AGREEMENT

STORM DAMAGE REPAIR TO ALDERPOINT ROAD
(F6B165) PM 2.10, 2.70 & 2.98
PROJECT NO.: ER-32L0(268/270/271)
CONTRACT NO.: 217245, 217247, 217248

CONTRACT CHANGE ORDERChange Requested by: Engineer ☒ Contractor ☐

SECTION VIEWS
SCALE: 1" = 20'

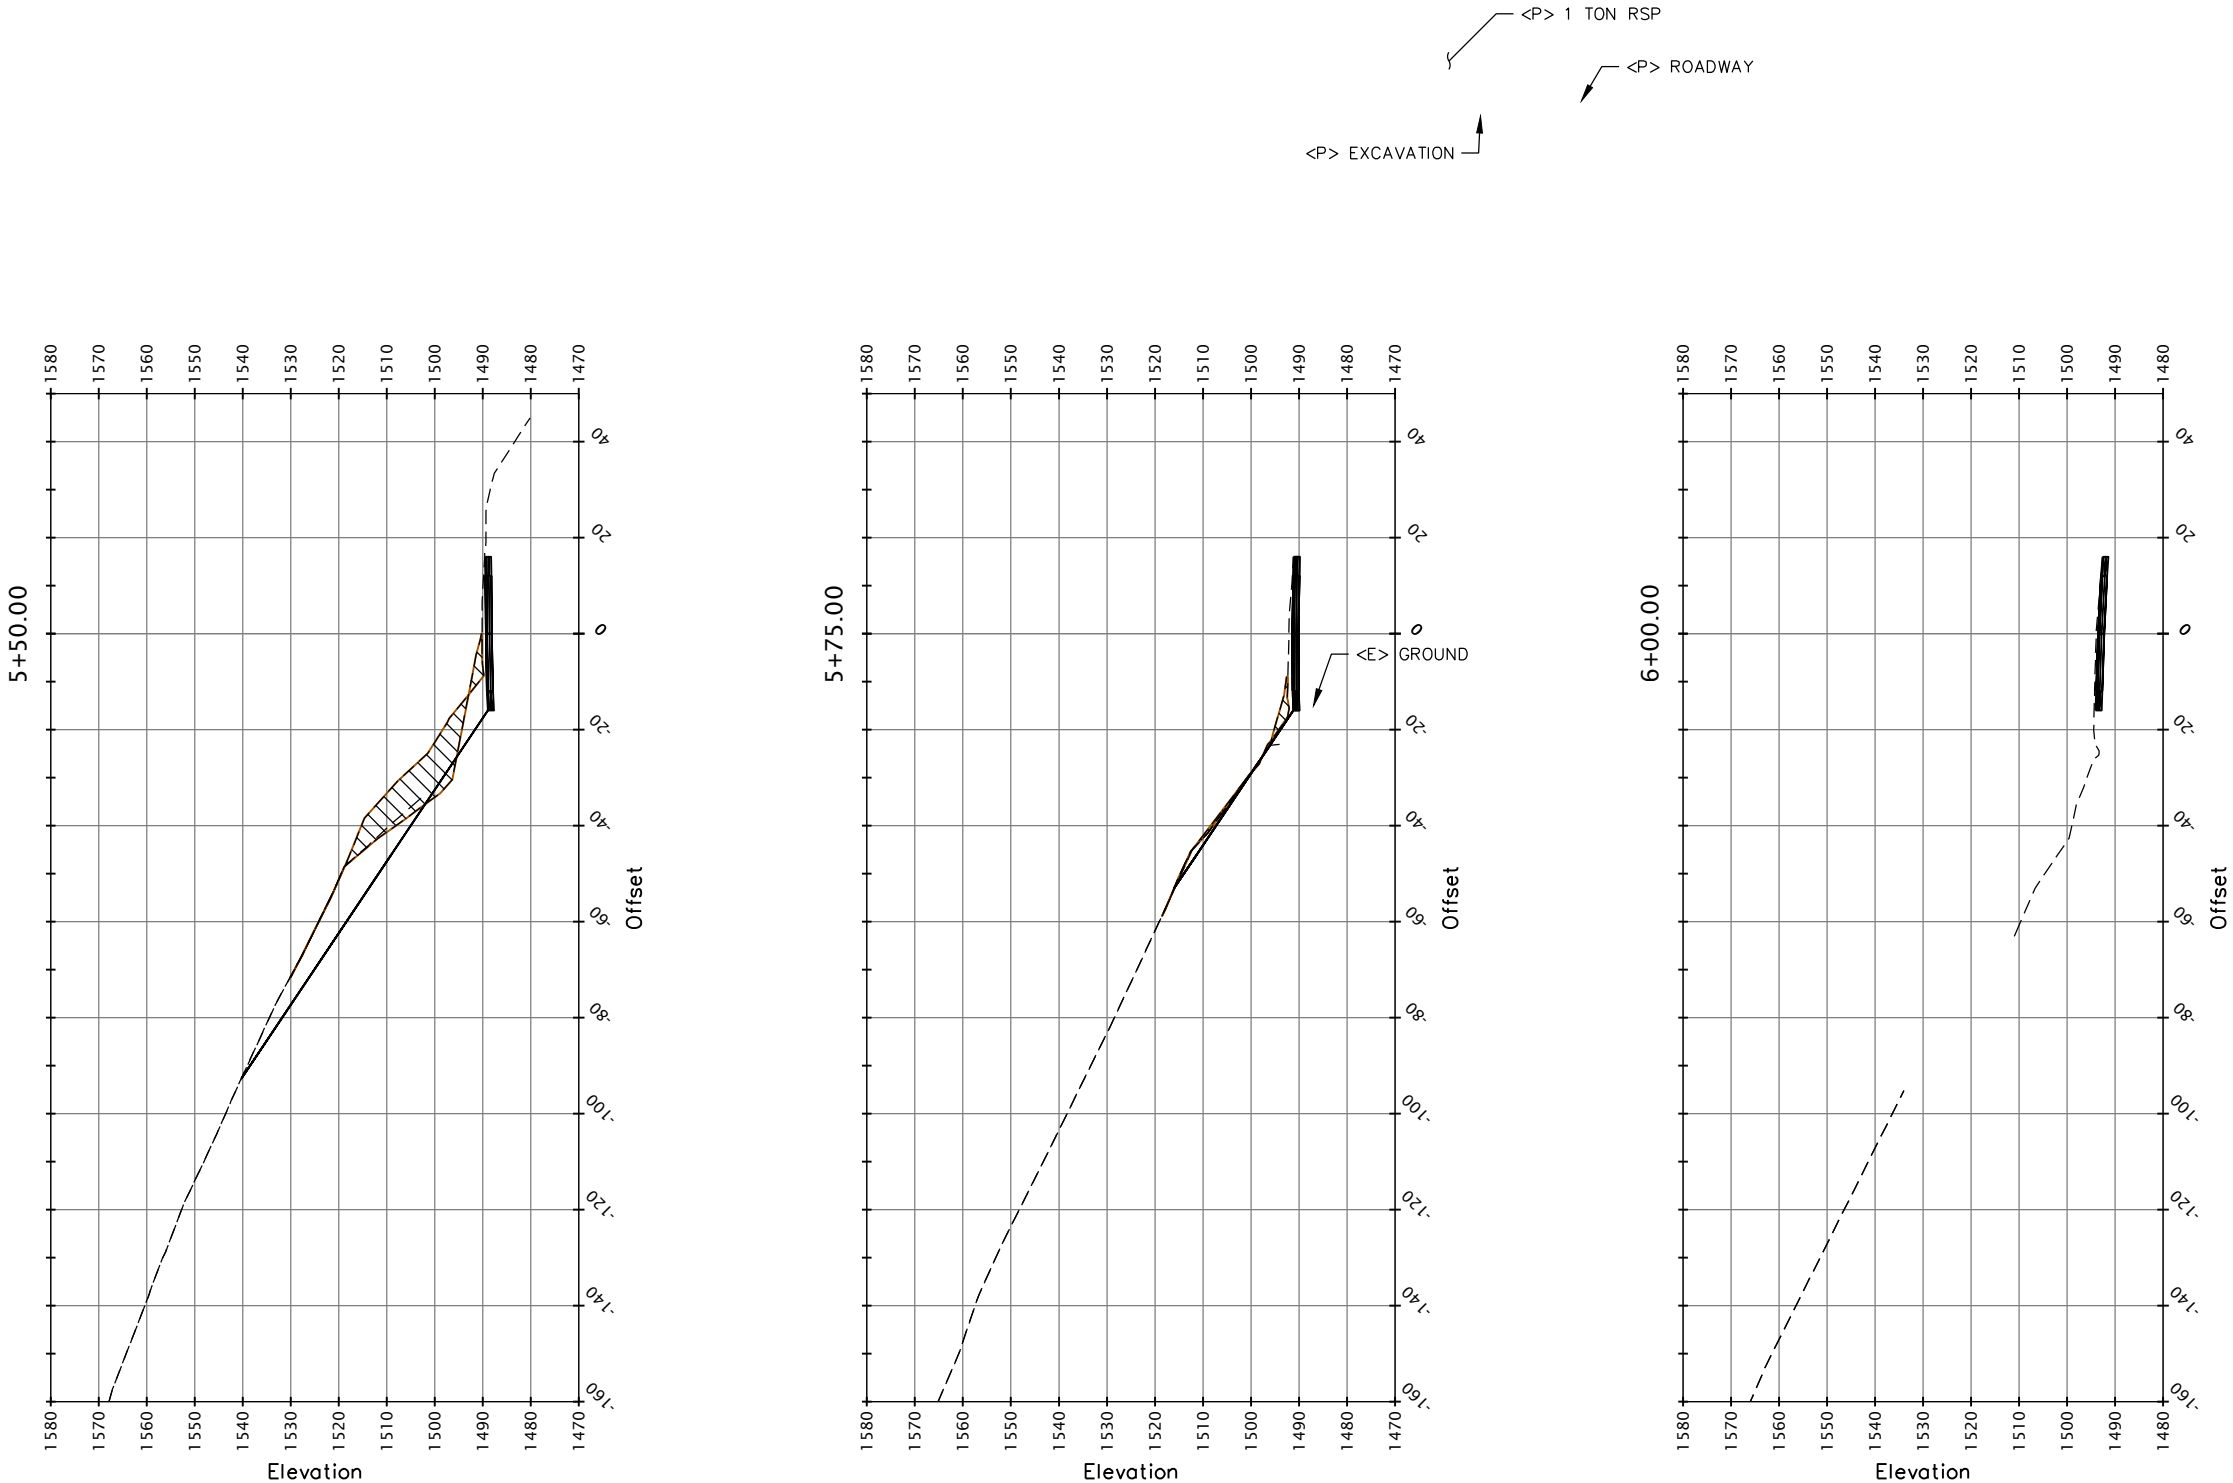
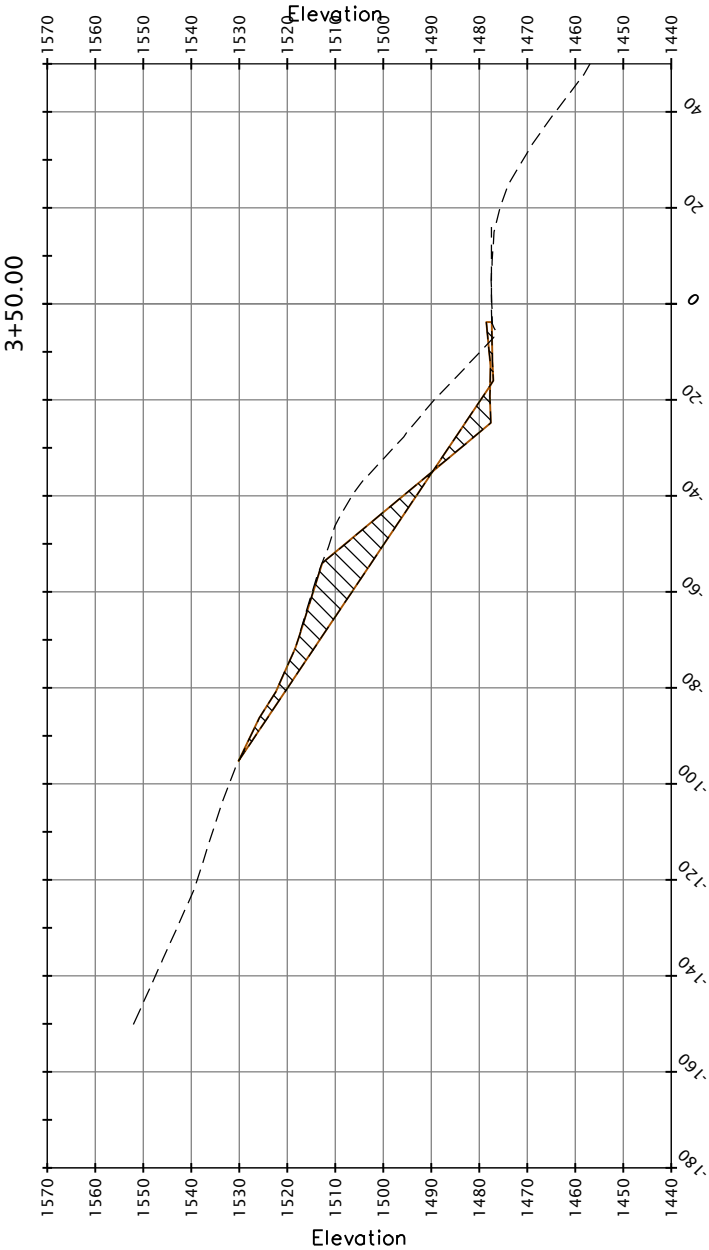
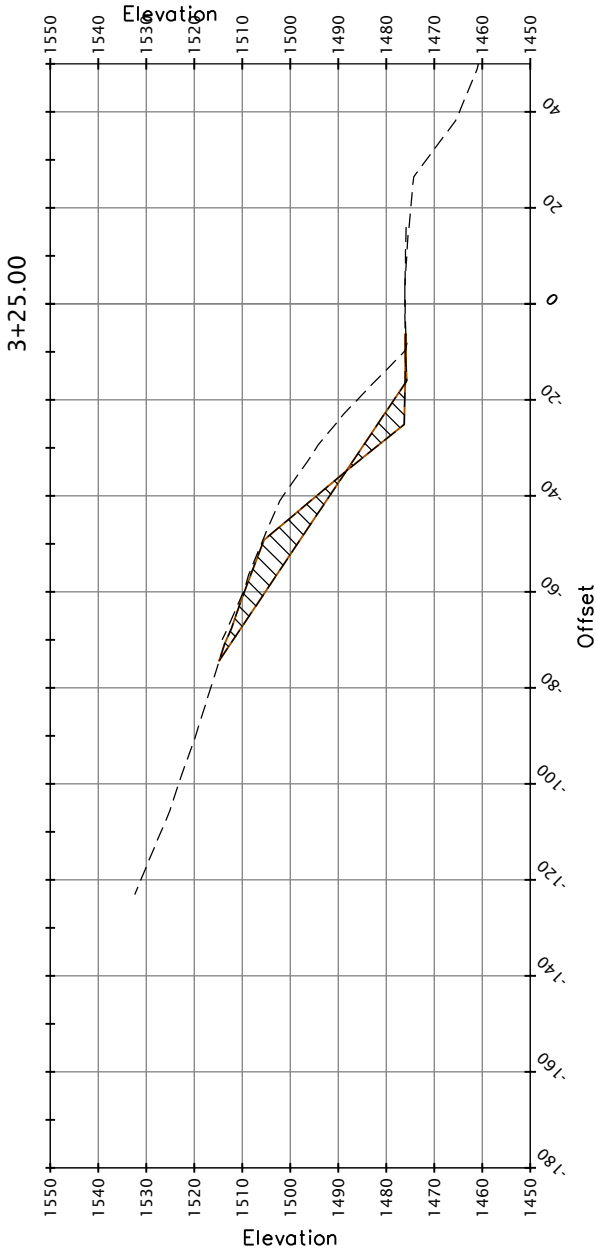
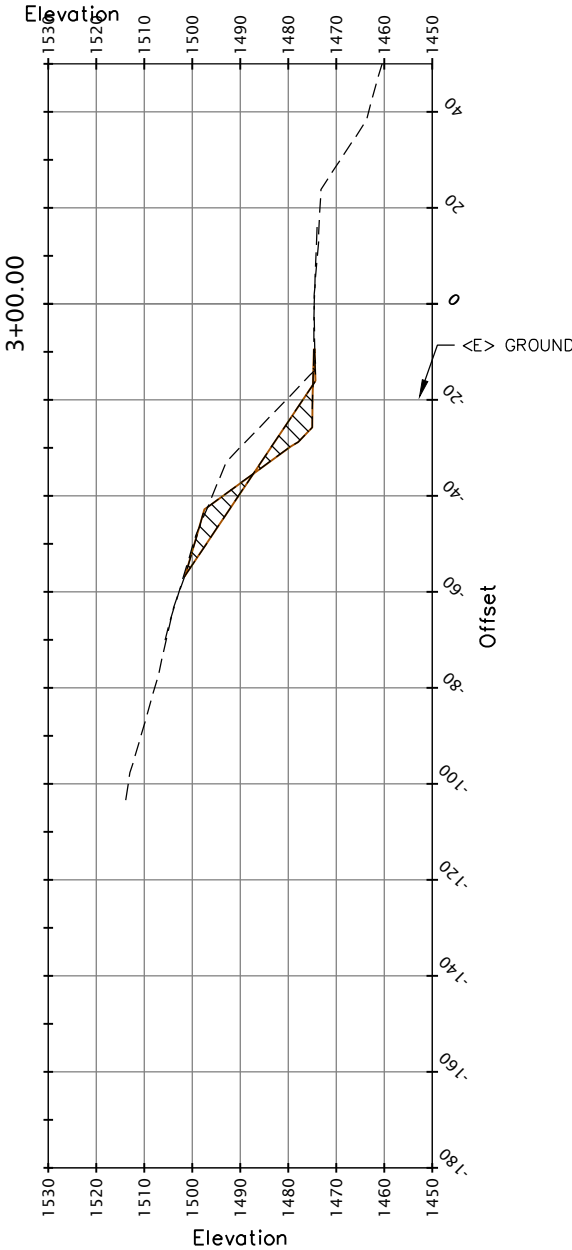
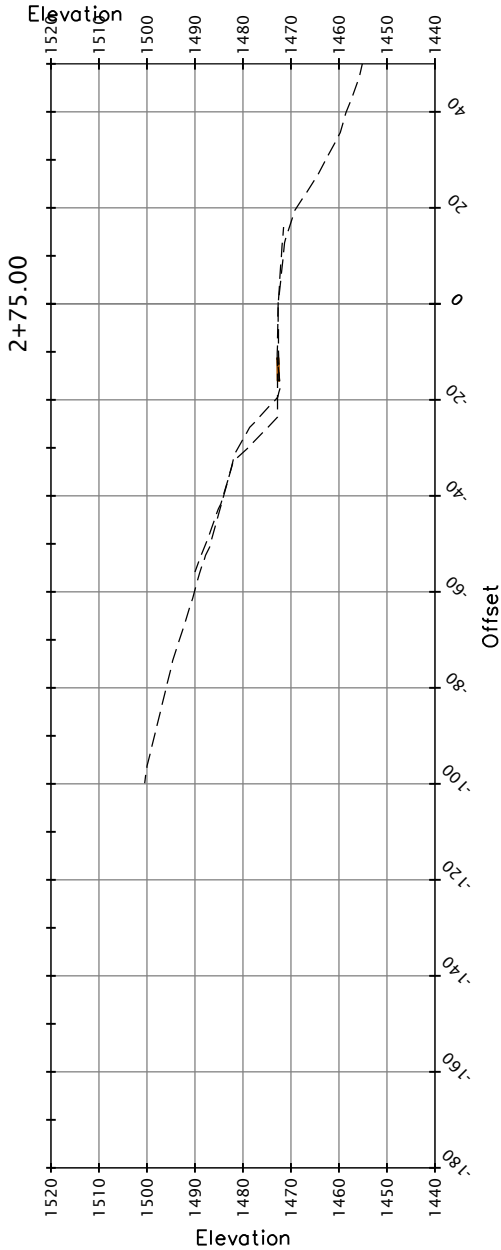
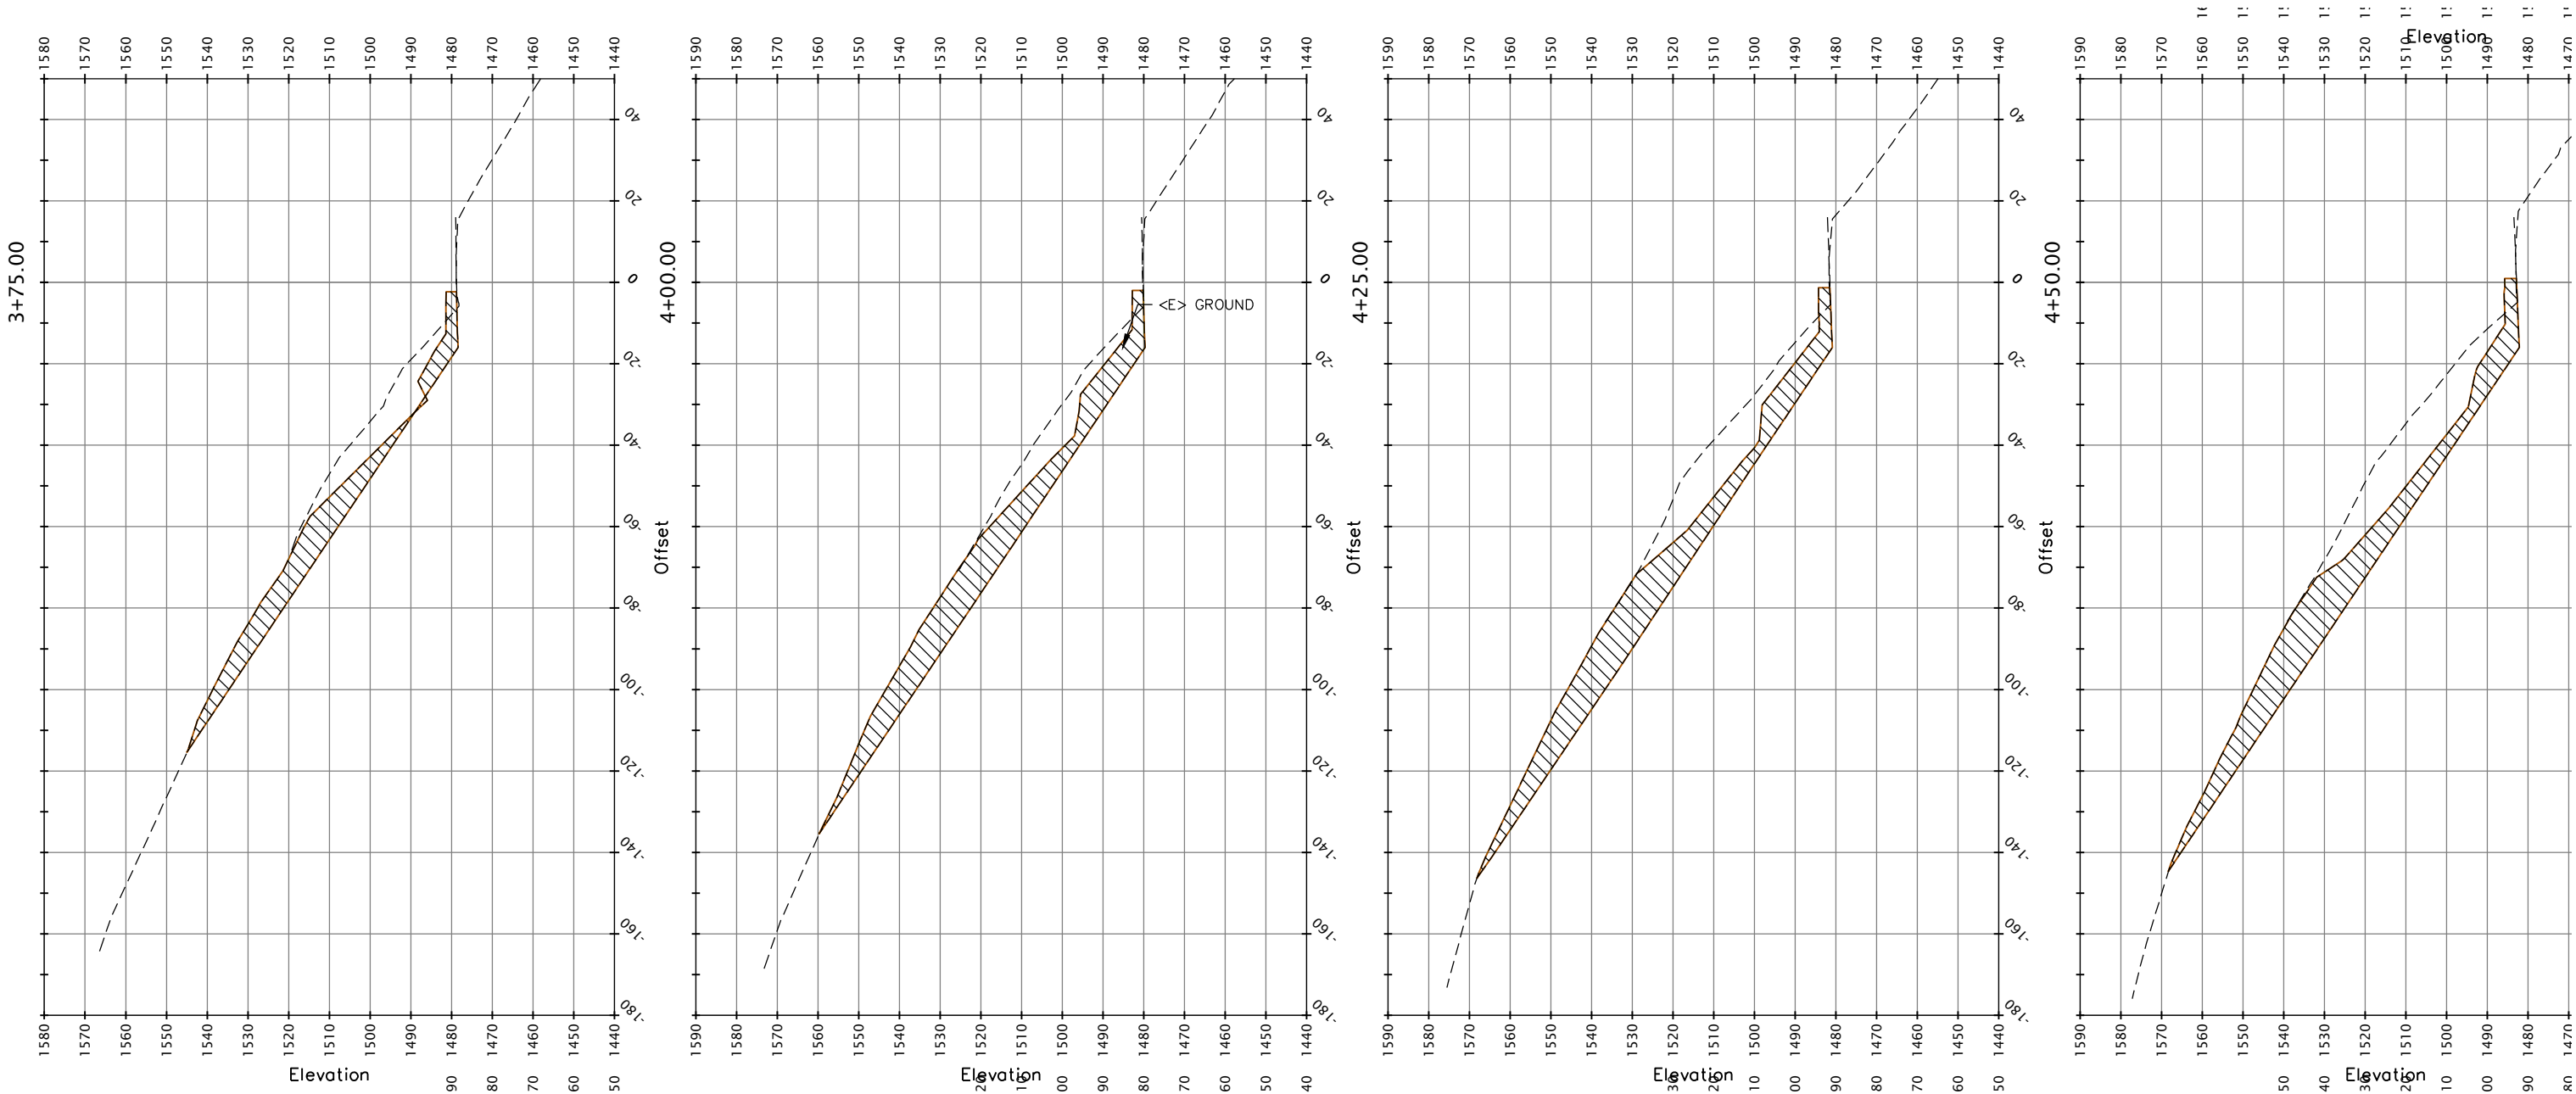
In accordance with Section 4-1.05 "Changes and Extra Work" of the Standard Specifications, replace sheets 6, 8, and 9 of the project plans with the attached plan sheets 6a, 8a-d, and 9a-d. Install 36" OMP and 18" Culvert near Sta 2+30 as directed by the Engineer.
